THE ABBOT BUILDINGS

PLANNING BOARD SPECIAL PERMIT PRESENTATION (REVISED)

PROJECT: The Abbot Buildings in Harvard Square
PROJECT NO: 17010.00
DATE: February 27, 2018

RE: Response to 01.30.2018 Planning Board hearing and
02.14.2018 meetings with CDD and Historic Commission

JFK ST. ELEVATION (REVISED)

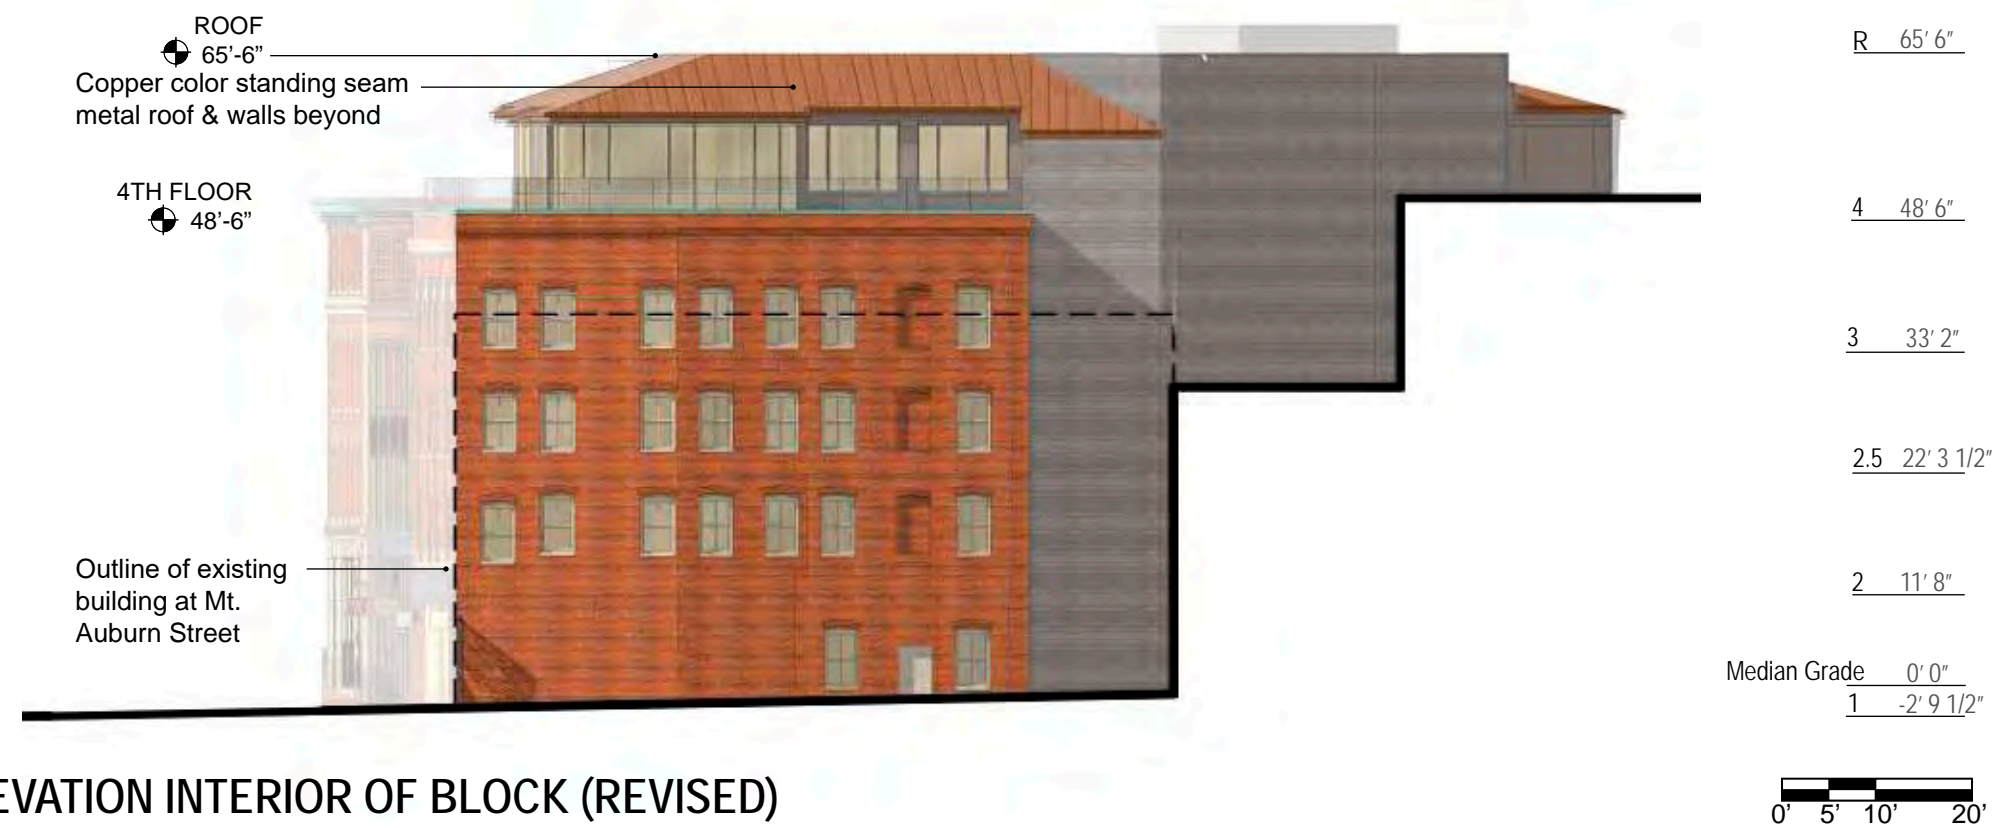
The 4th floor design was understated and the grey roof and bay detailing needed to be more special.

The recessed brick bay in the center of the JFK façade seemed unnecessary. The interrupted storefront would be more difficult to sub-divide.

The revised design includes changing the roof material from a grey metal to a copper colored standing seam metal roof, thus adding warmth to the roof.

The revised design also adds more glazing on the Brattle Street façade with glazing wrapping around the corner facing Brattle Square per Planning Board comments. The window glazing and mullion design and detailing has been revised to be more modern and elegant in its approach, taking a cue from the rooftop addition to the Swiss Consulate on Broadway.

The revised design has eliminated the center bay recess and simplified the façade design along JFK Street enabling more flexible retail tenancy.
